CENTRAL AVENUE CONNECTOR TRAIL

30% Design Project: Phase I—Addison Road Segment

THE MARYLAND-NATIONAL CAPITAL PARK AND PLANNING COMMISSION
PRINCE GEORGE'S COUNTY PLANNING DEPARTMENT

JANUARY 2017

Figure 4. Typical Section

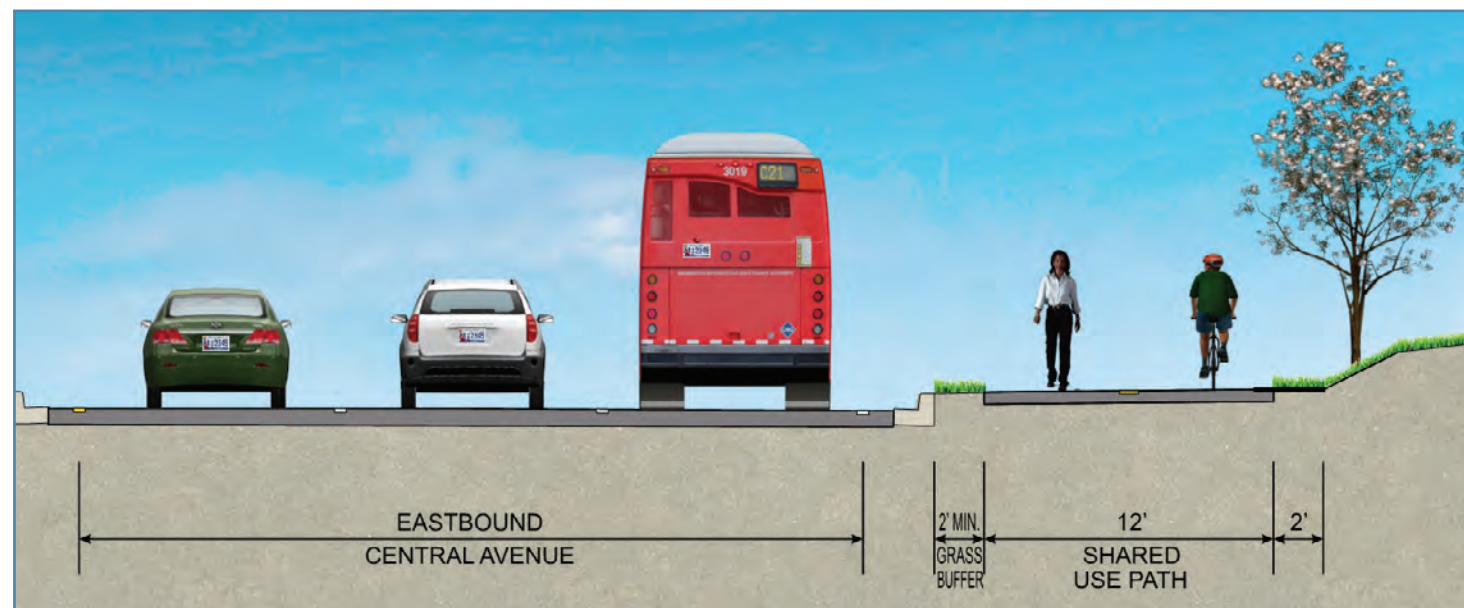
6	Report page 8	PLNT	In the study document on page 8, Figure 4 rendering of the trail in place of the old sidewalk omits the bus stop. Wouldn't this require pavement? This will increase impervious area. There are at least two bus stops that will need to be addressed on WMATA property.	Connections will be maintained at all bus stops. M-NCPPC will coordinate the design details with WMATA in final design.	
7	ALL	PLNT	Confirm the proposed slopes being created as part of the work will be able to be maintained safely with equipment. Do not exceed 15 degrees of slope.	Slopes along the trail are proposed at 2:1 in order to minimize impacts to existing facilities. Modification of slope grades will be reviewed with WMATA during final design. Max slope is 5%.	
8	Drawing 14 of 25	PLNT	This drawing indicates provision of bioswale. Additional maintenance impact on WMATA if we're to be responsible for it.	M-NCPPC will continue to work with WMATA and other stakeholders to develop a maintenance plan for the trail

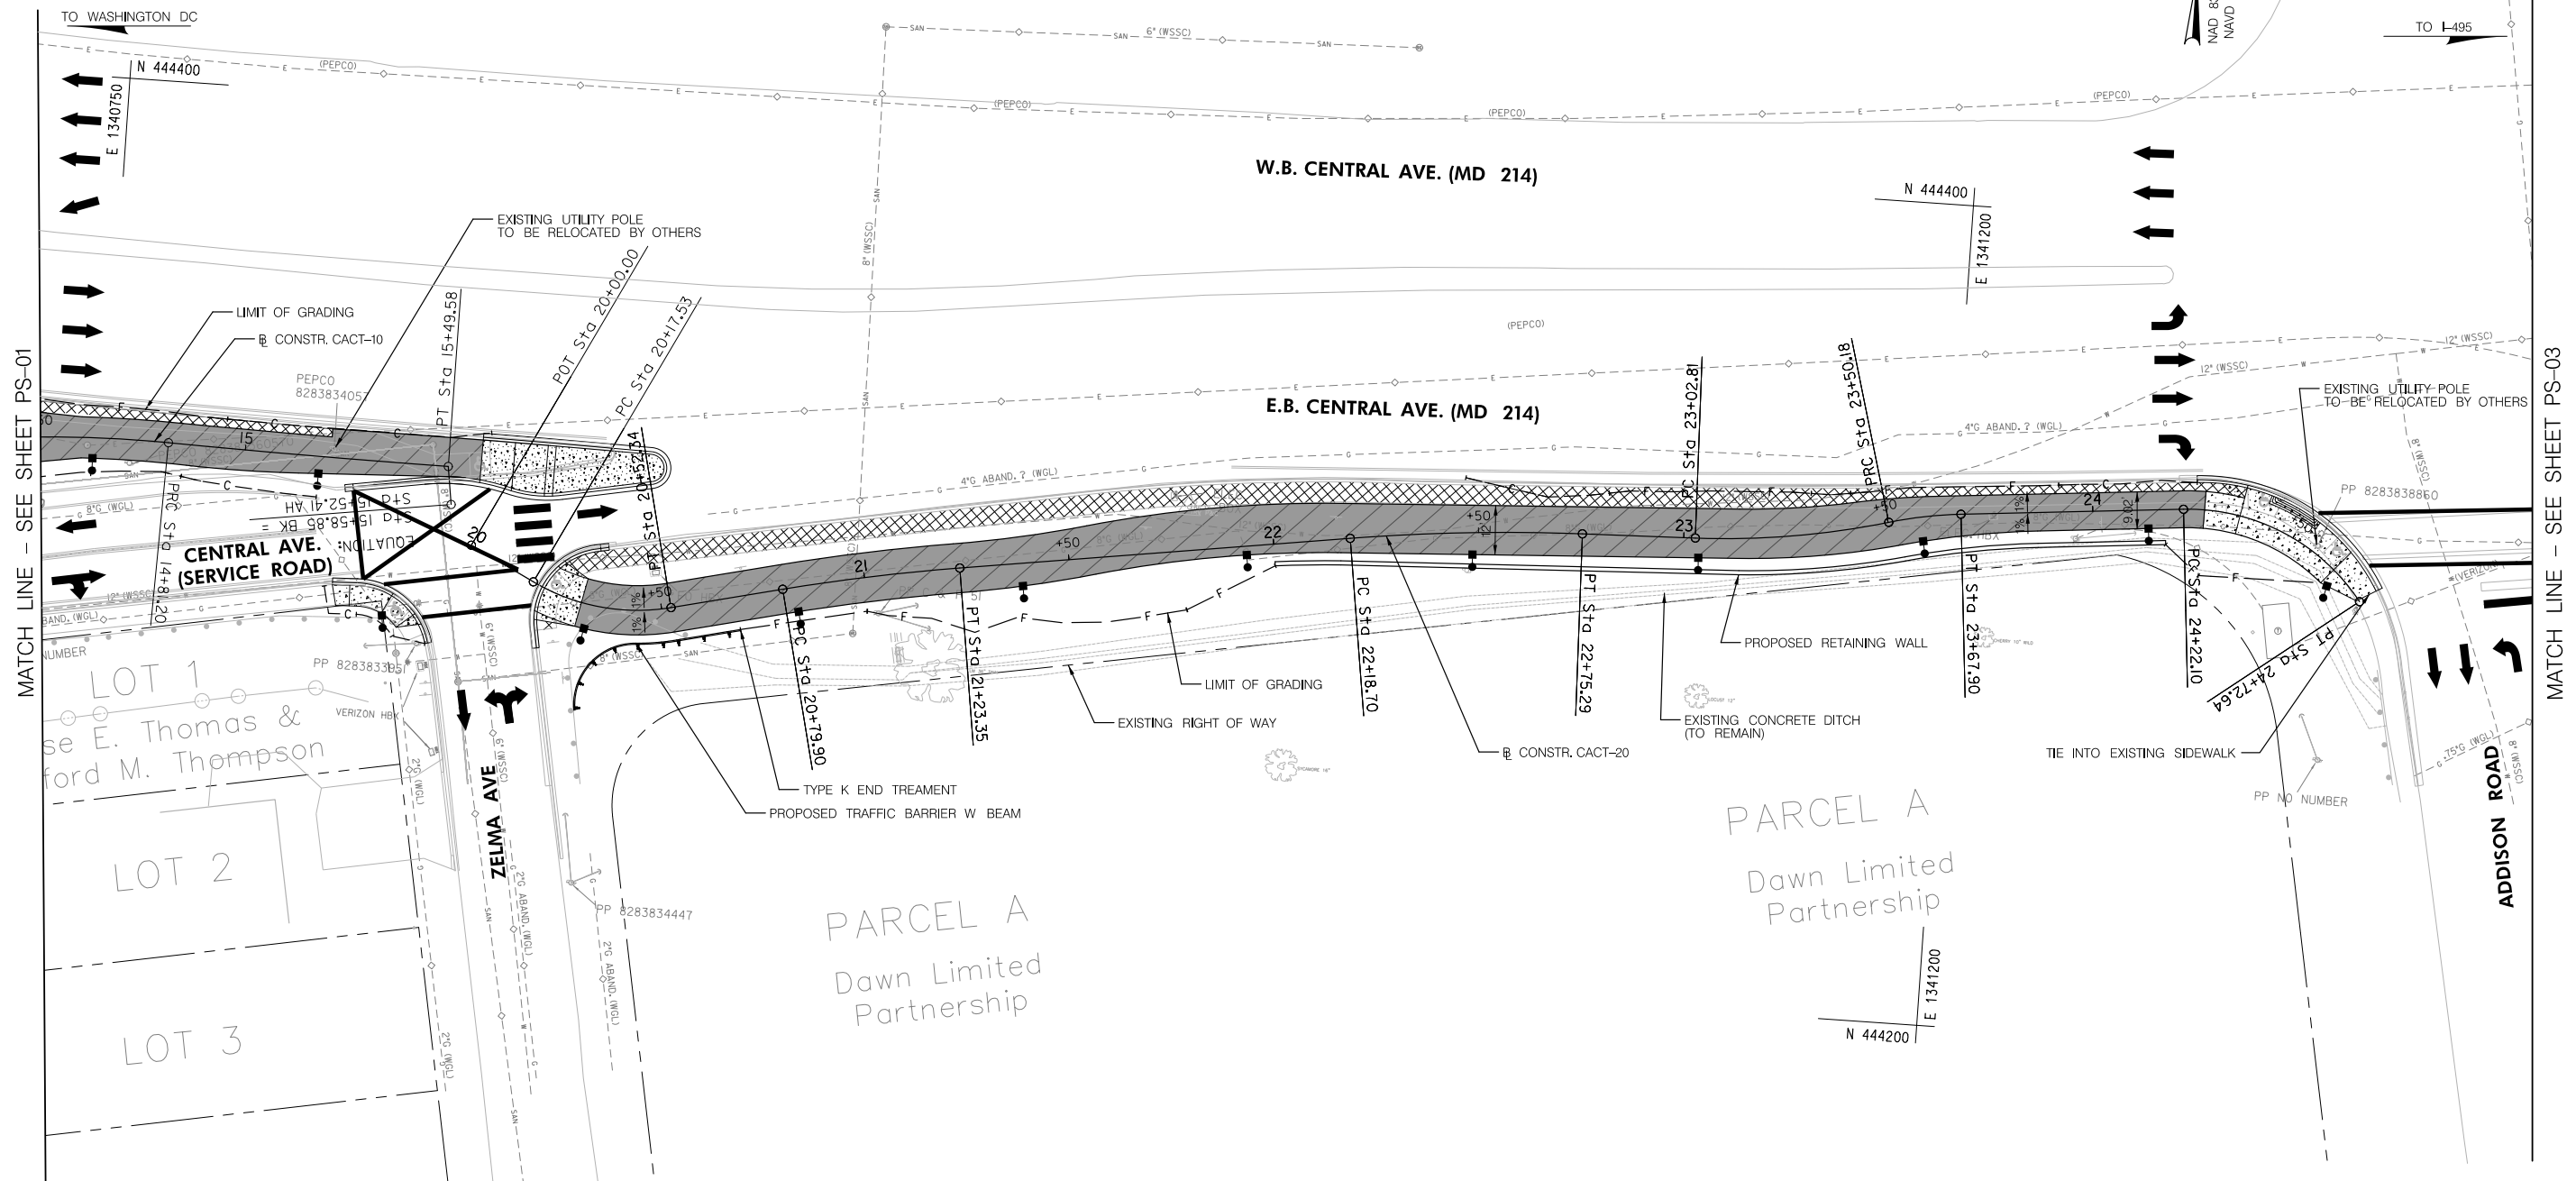
COMMENT NUMBER	30% SHEET NUMBER/LOCATION	DEPARTMENT	COMMENTS	M-NCPPC COMMENTS	STATUS/COMMENT OR DIRECTION/ACTION
31	Sheet 8	PARK	Flare of ramp next to Station 15+49 appears that it should be eight feet in length if there is an eight-inch curb.	The flare is designed to be eight feet long. Details of the ADA ramps providing dimensions will be provided at the next submission.	
32	Sheet 8	PARK	Curb ramp past Station 24+22 flare should be eight feet long if eight-inch curb and should align into the crosswalk. It is unclear if there is a northbound crosswalk.	The flare is designed to be eight feet long. Details of the ADA Ramps providing dimensions will be provided at the next submission.	
33	Sheet 9	PARK	Show existing crosswalks to determine appropriate movement of pedestrians and bicycles.	Additional details will be provided during final design.	
34	Sheet 9	PARK	Curb ramp opposite Station 10+00 curb ramp does not seem to be aligned. Also, curb radius is very wide on that side.	Curb radius is designed to match existing curb at the intersection. The proposed crosswalk alignment has shifted from existing conditions and will require new crosswalk pavement markings.

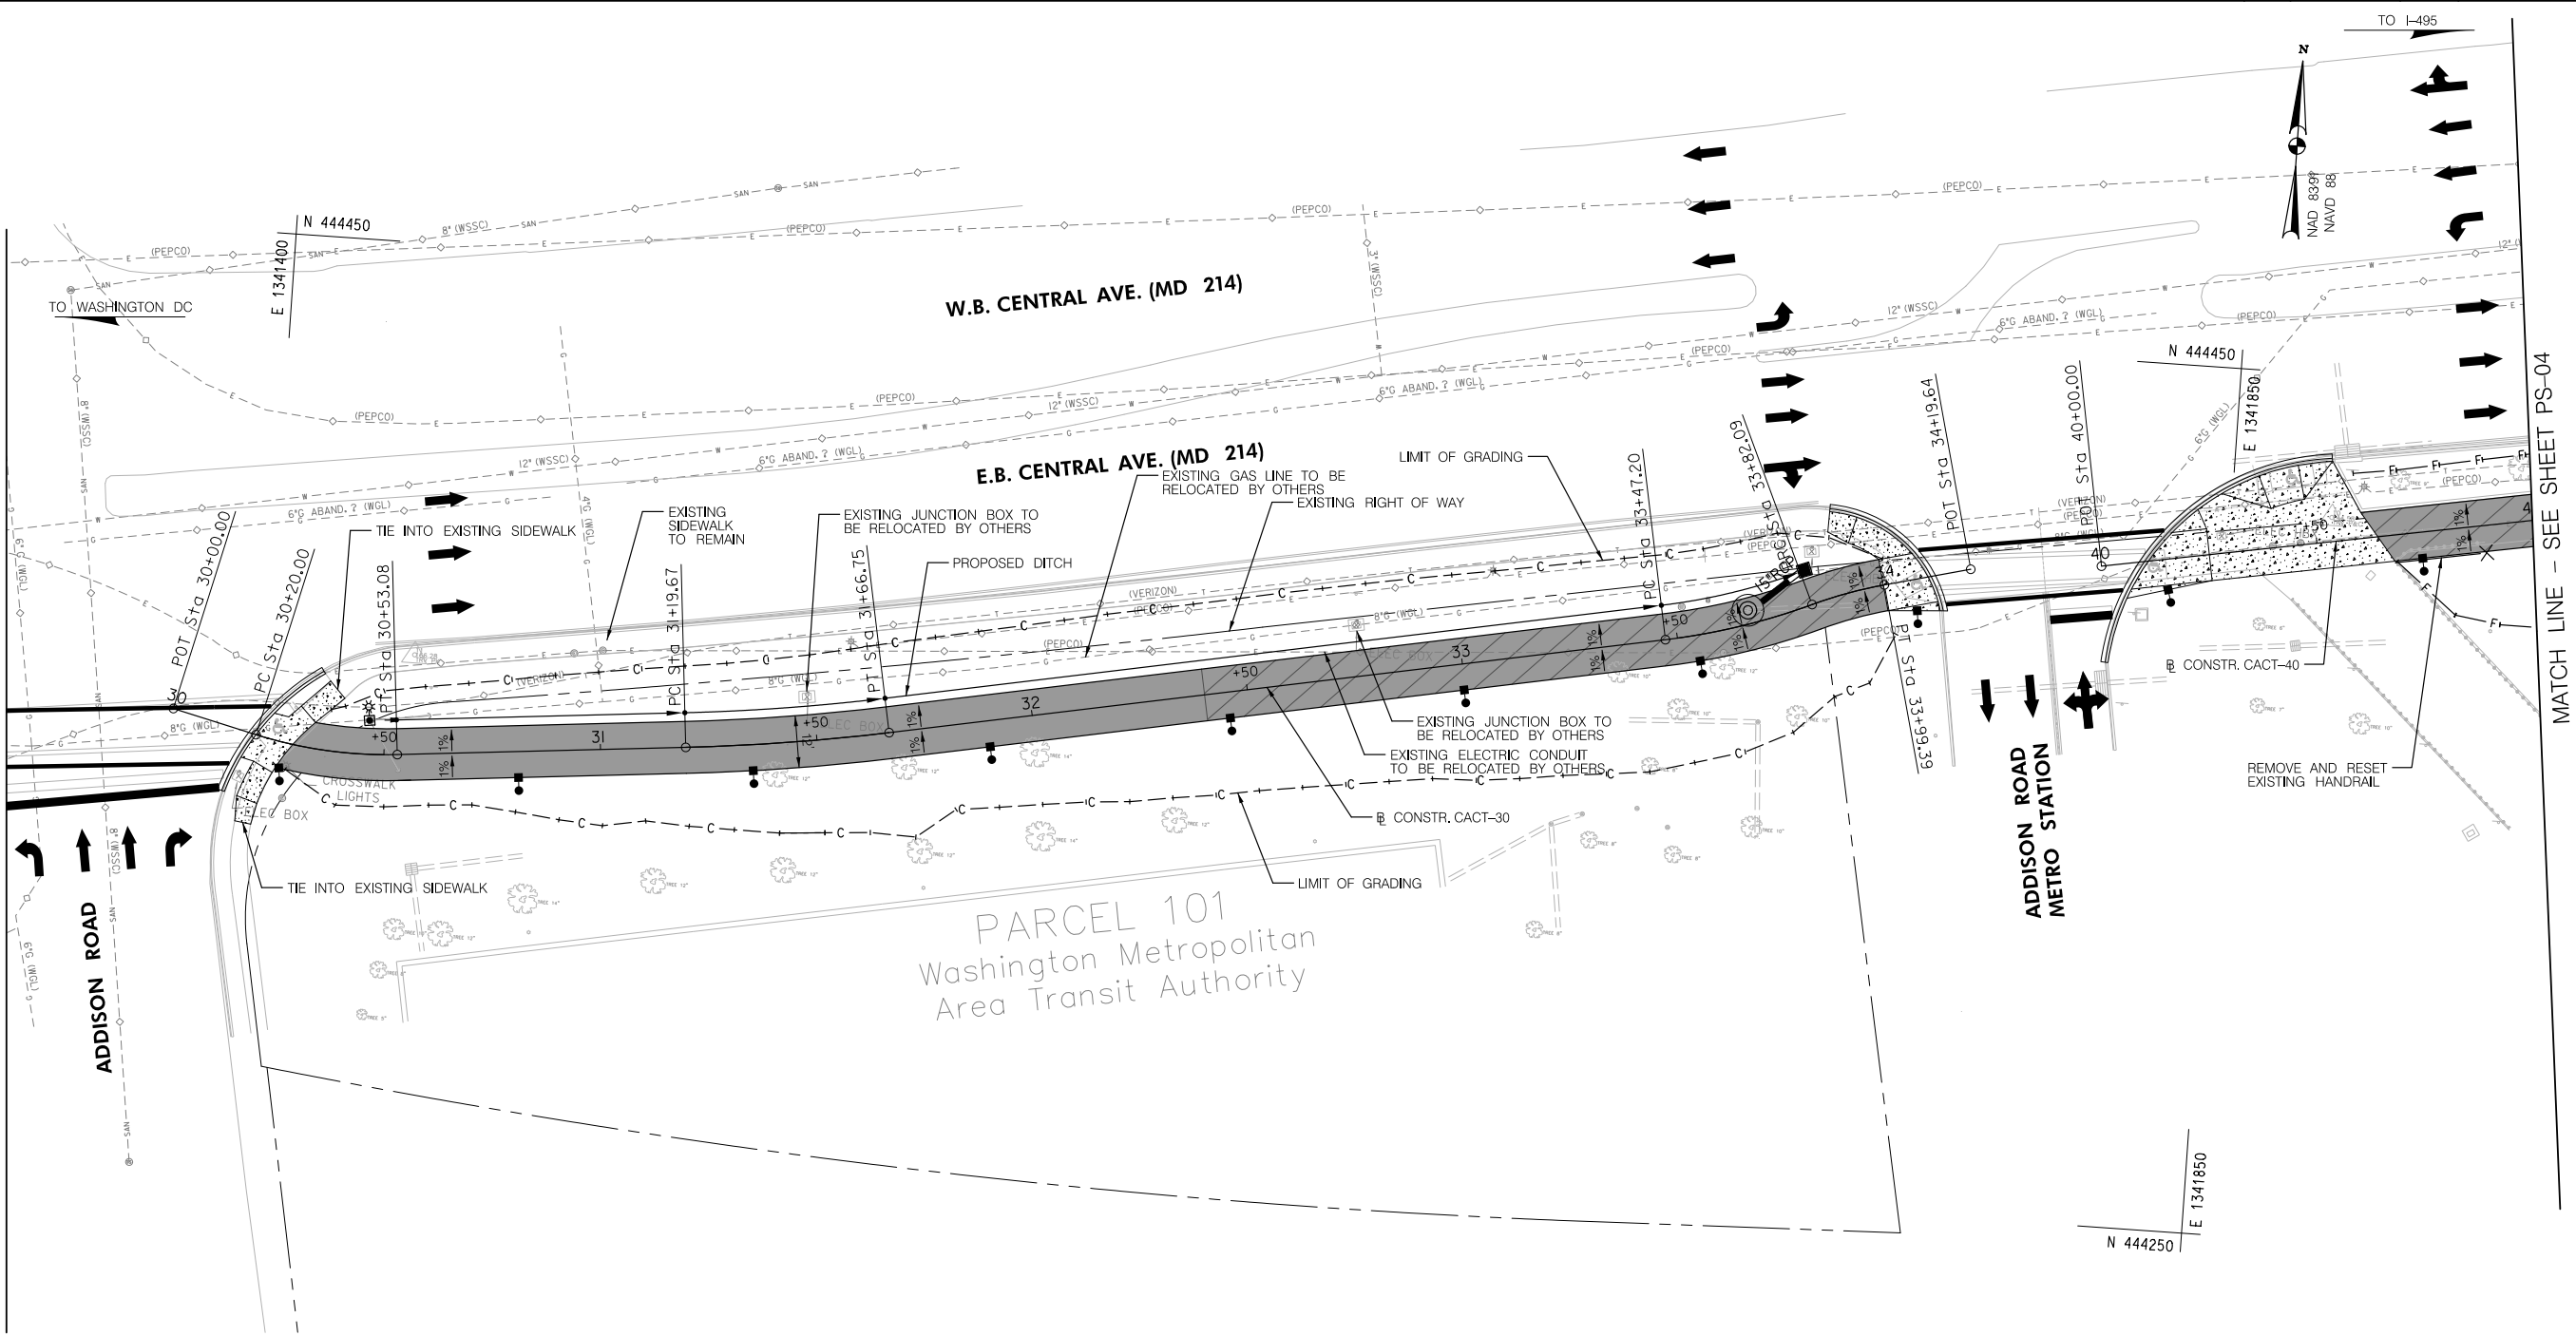
35	Sheet 9	PARK	Station 40+60 reset handrail a minimum of two feet from edge of path per AASHTO.	Railing requirements and details will be further evaluated during final design.	
36	Sheet 9	PARK	At Station 40+40, is there a northbound crosswalk and receiving ramps on the island?	Crosswalk details will be further evaluated and developed during final design.	
37	Sheet 9	PARK	Proposed ditch starting at Station 44+79 should have a two-foot shoulder or use AASHTO Guide for other options.	In locations of proposed ditch there is a two-foot shoulder from the edge of the trail to the hinge point at the top of the ditch.	
38	Sheet 10	PARK	W-Beam traffic barrier should have a 42-inch high railing attached per AASHTO due to drop off on other side.	Traffic barrier attachment options will be reviewed at the next submission.	
39	Sheet 10	PARK	What is agreement for the impervious pavement maintenance? Indicate entire responsible for maintenance.	Implementing agencies do not recommend impervious pavement. We will likely be looking at alternative treatments.
